**DATE** July 19, 1990**ATTENTION** Ms. Christy O'Quinn  
Project Manager**REFERENCE** C86-167**WE ARE SENDING YOU:**

SEATTLE CITY LIGHT WORK ORDER #90-6

1990 SPRING MONITORING OF THE GEORGETOWN FLUME

*H-CL-Revisions, comments & questions to be answered.*

Draft Figure 2

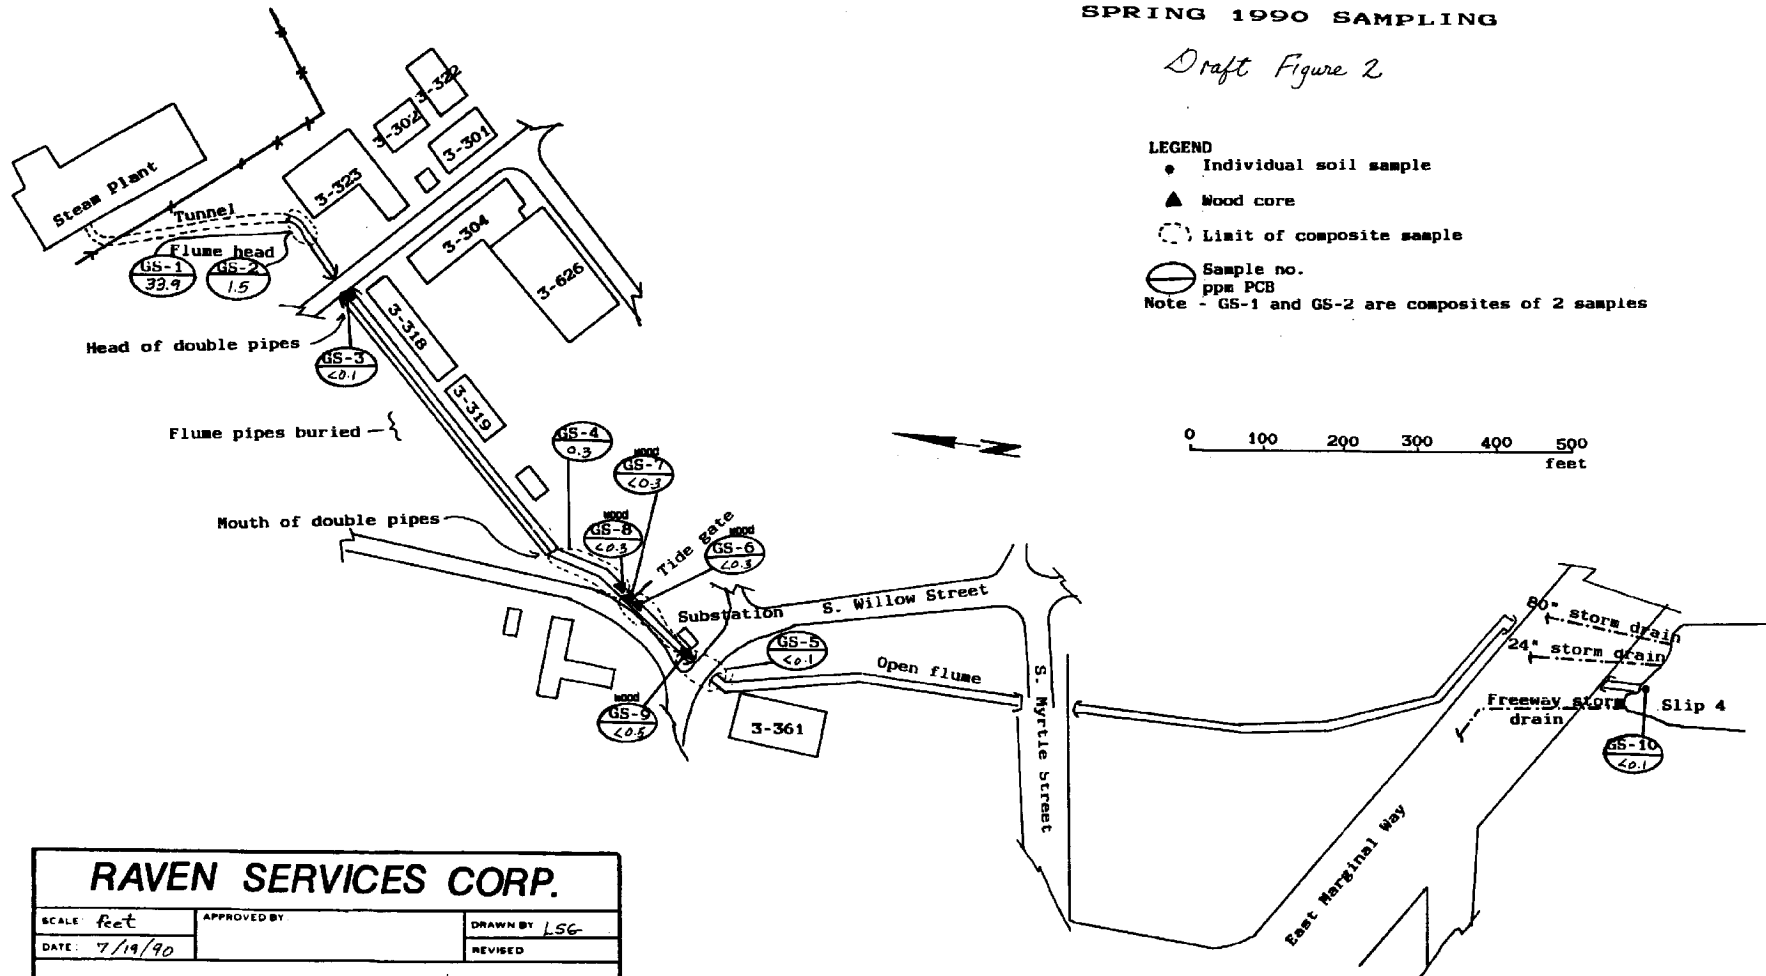
*sample locations?*

The PCB results are listed by Aroclor in Table I and those in the flume are *shown* located in Figure 2. ~~The composite sample from the head end of the flume head (the barrier)~~ contained 33.9 ppm; *near the tunnel entrance* near the mouth of the flume head, 1.5 ppm was found. In the composite of four subsamples above the tidegates, 0.3 ppm was found. The other composites including the Slip #4 sample displayed no detectable PCB signals. The wood cores (whose detection limit reported in Table I is higher because the sample size was smaller) also displayed no detectable PCBs.

Draft Figure 3

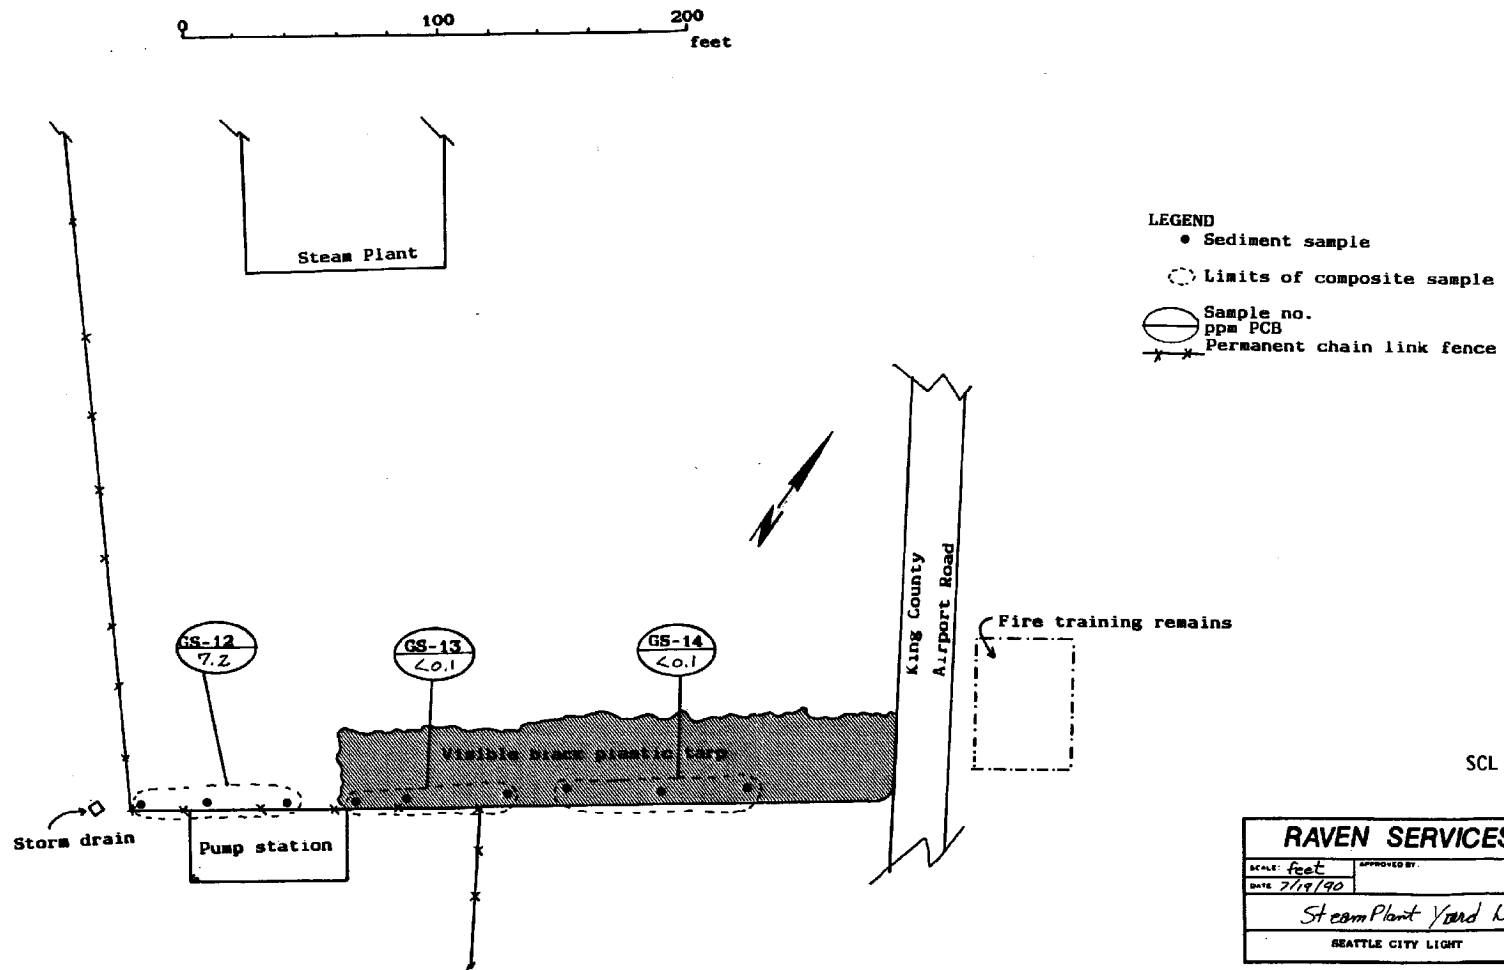
③ The current work order (90-6) also involves reassessment of PCB levels in the 1985 cleanup area. ~~This sampling~~ <sup>results</sup> Sampling locations ~~are~~ <sup>shown</sup> in figure 343.

*? Soil collected area*  
Sediment samples gathered in the Steam Plant yard ditch for this monitoring period are also listed in Table I. The sample locations are plotted in Figure 3. Of the three composites collected, only the site of the old catch basin contained sediments with detectable PCBs (7.2ppm). *a* The physical description of all the samples in this study *is provided* are given in Table II.
